#### CITY OF MARLBOROUGH MEETING POSTING

Conservation Commission

September 2, 2021 (Thursday)

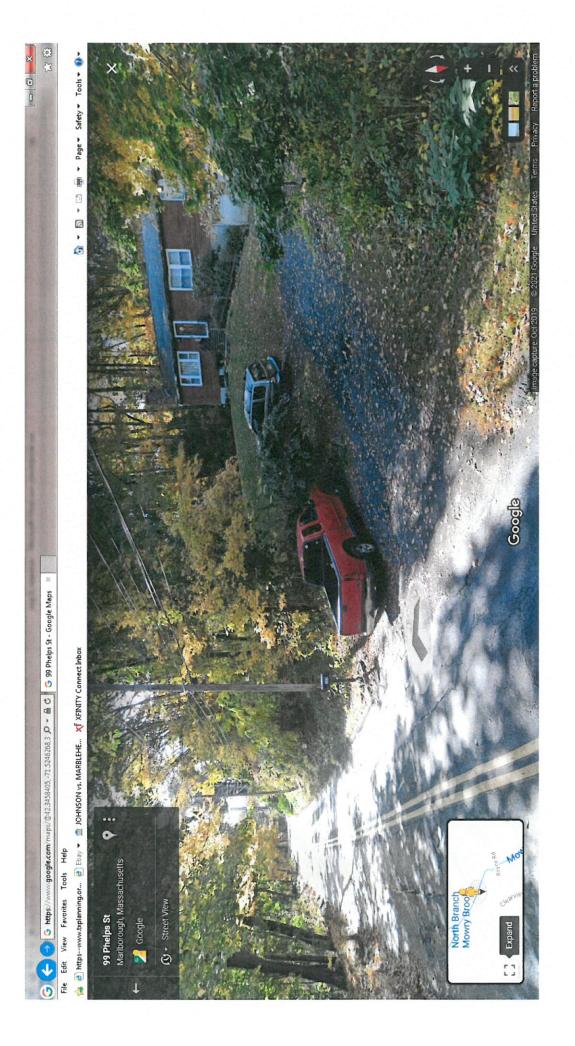
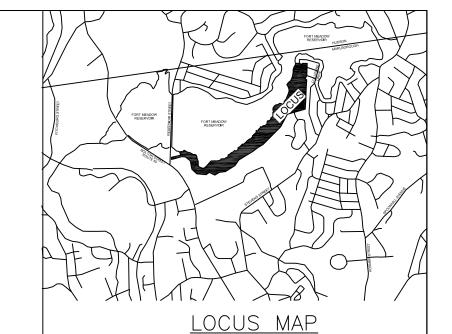
So of the 78,425 s.f. how much of that is within the riverfront area? The regulations allow for the disturbance of 5,000 s.f. or 10% of the riverfront area, whichever is greater on a lot recorded before Oct. 6, 1997. It would be good if you (or Mary Ann) can provide a brief description on how this project meets the 310 CMR 10.58 (4)3. (d). No Significant Adverse Impact section. That will assist the Commission in their review.

In response to the questions of impact areas and No Significant Adverse Impact we submit the following on a slightly revised plan depicting the below calculations of disturbances, and photographs demonstrating additional information in support of the No Adverse Impact.

It is clear from the above that the disturbance area to natural Riverfront area can be considered to be 5050 sf total for the two lots.

- 1. Impacts less than 5000 sf of natural riparian habitat.
- 2. Less than 10% overall of the RFA for both lots.
- 3. Has no **significant impact** in the driveway access easement which consists of predominantly lawn area.
- 4. Effects the intent of the City to create the lot with necessary (ANR) frontage where unlimited rights of access across the former City land was provided for in the original taking around 100 years ago.
- 5. Further reduces that originally proposed on June 3, 2008 by the City DPW (copy attached, annotated to show the approximate disturbance of 20,000 sf), thus this is a "practicable alternative with less impacts."
- 6. The existing lawn area is subject to disturbances from sewer line maintenance notwithstanding the proposed driveway.
